From: McWade, Tammy [mailto:Tammy.McWade@dep.state.fl.us]
Sent: Wednesday, June 29, 2011 1:21 PM
To: Velasco, Robert A.
Subject: RE: TECO Big Bend Station Project No. 0570039-047-AC

In response to your request, please find the following clarifications to the carbon capture permit application No. 2959-1:

Emission Inventory Work Sheet

Big Bend Power Station
Tampa Electric Company
Facility ID No. 0570039

PM and PM₁₀ Emissions

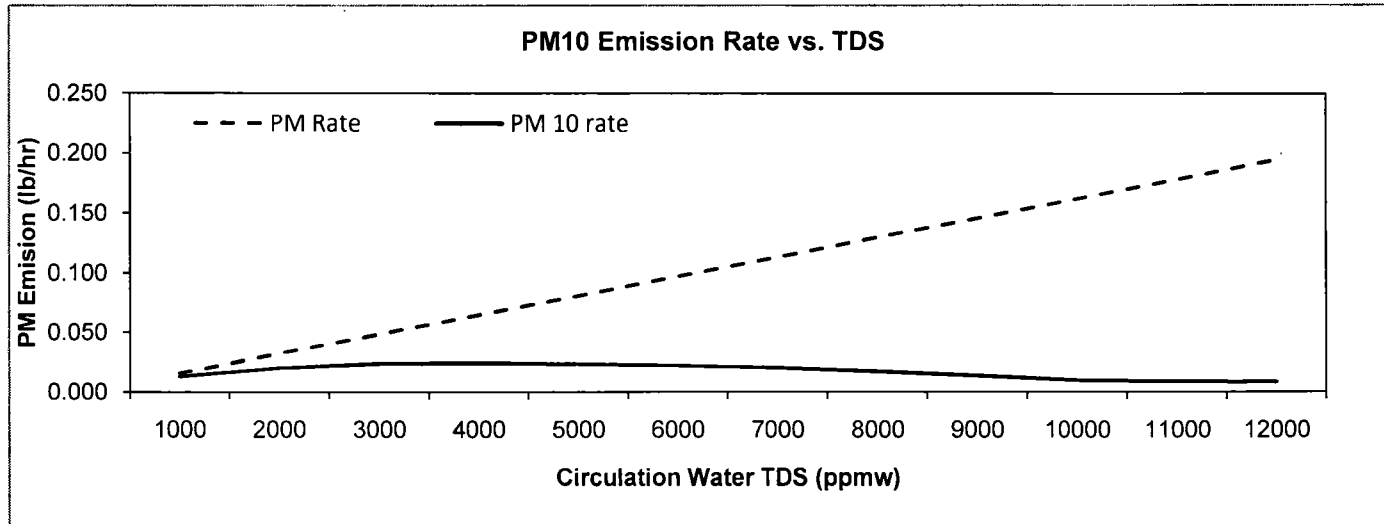
From: McWade, Tammy [mailto:Tammy.McWade@dep.state.fl.us]
Sent: Friday, July 01, 2011 3:30 PM
To: Velasco, Robert A.
Subject: RE: TECO Big Bend Station Project No. 0570039-047-AC

Rob, can you send me the PM10 Emissions Rate vs. TDS graph in excel or the numbers used to plug in so I can re-graph it. I am having a hard time copying this one and making it clear. It is just for the technical for reference.

The calculations were revised to show the PM emissions at the specific design conditions (see attached). The PM rate was calculated as the product of the TDS concentration, drift rate (0.0015%) and water recirculation rate (2160 gpm). The PM₁₀ rate was calculated using the PM emission rate and correction factor by Reisman and Frisbie (2001). The correction factor was computed using the design TDS concentration, a realistic drift particle size distribution and a conservative 0.0006% drift rate. Based on these calculations, the cooling tower is exempt from air permitting pursuant to Rule 62-210.300(3)(b), F.A.C. since the PM emission rate is substantially below the 5 tons per year criteria.

<u>PM emission rate</u>	<u>PM₁₀ emission rate</u>
0.18 lb/hr	0.0091 lb/hr
0.78 tons/yr	0.040 tons/yr
